PRODUCT CHANGE NOTIFICATION

Bourns® Model SRF0703 Series Dual-Winding Shielded Power Inductors

Mounting Base and Shield Design Change

IC209919

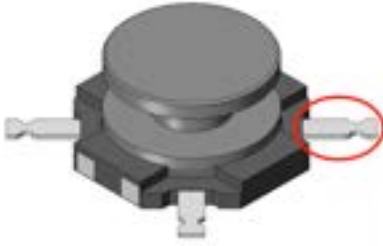
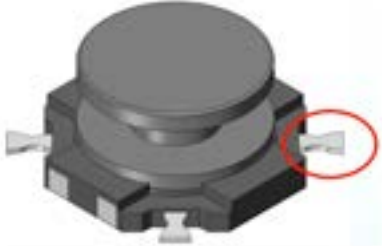
Current Mounting Base	Revised Mounting Base
 Long terminal pin	 Shorter terminal pin
 No terminal anchor	 Terminal anchor embedded in mounting base to increase terminal stability

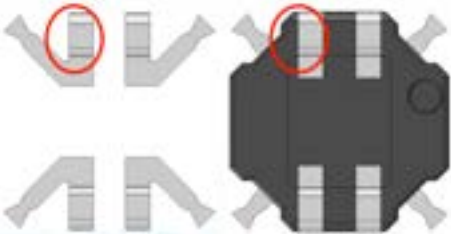
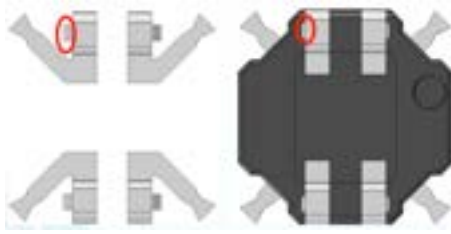
Current Shield

No wire channels

Revised Shield

- 1) Redesigned four corner channels to increase assembly space
- 2) Added four wire-channels

Current Appearance of Full Assembly**Revised Appearance of Full Assembly**

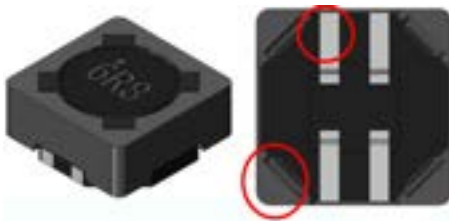
The form of the redesigned shielded power inductor will change. The fit and function will remain unchanged. The reliability and quality of the redesigned shielded power inductor should be improved as a result of the mounting base and shield redesign. Samples are available upon request.
